Pulsar Ila Design Review Summary

with answers to reviewer's questions

We would like to invite you to review our Pulsar IIa ATCA based Data Formatter *prototype* design. **The review will be held on Nov. 14th, 1:30pm to 4:30 pm**, at Wilson Hall, 10th floor, Room 1000 (next to men's room).

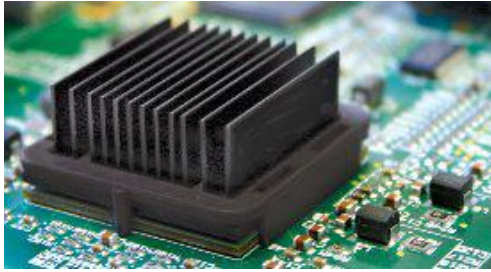
3) Suggest that adhesive heat sinks will probably suffice for your FPGAs.

Clip on or adhesive heat sinks will be used:

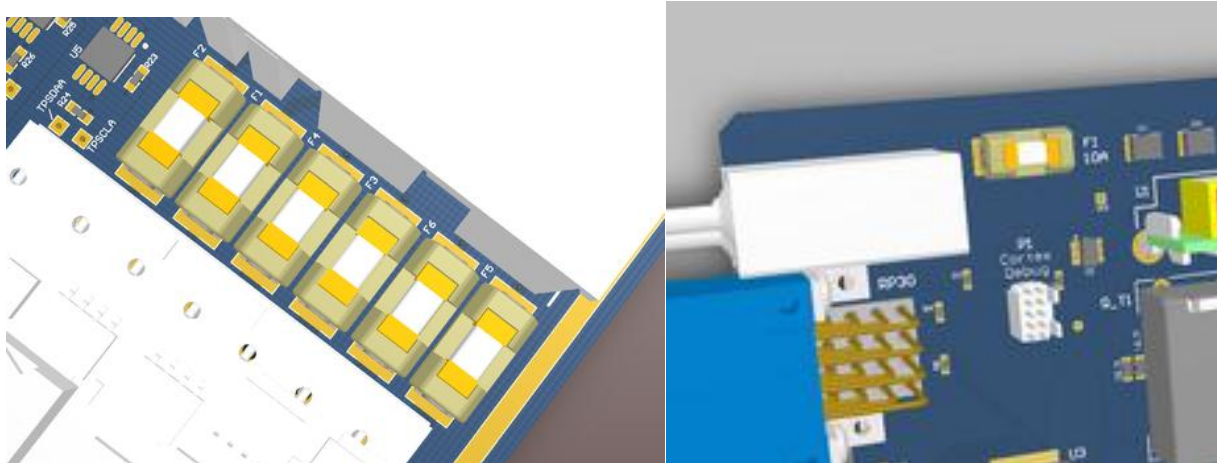
- B. Sheet 4/17: As we talked on the meeting, we should add a 75 ohm resistor to ground from C5. Commercially, a 75 ohm resistor should connect from C5 to RJ45 shielding. Since you don't use RJ45, it should connect it to ground instead. The 75-ohm resistor to ground will provide a path to reduce the unbalanced differential current that will turn to a low frequency noise after filtered by C5. In addition, it also helps provide the impedance matches, i.e. ~110 ohms seen from any center pins of the transformers. Well terminated center pins will help reduce both common mode and differential mode EMI noise.

- C. C5 should be rated at above 2KV, it will help prevent from lightning damage induced from Ethernet cable. It is all about the safety.

Added 75 ohm resistor from net ETH_FILT to ground.

Changed C5 to 1000pF 2000V capacitor.
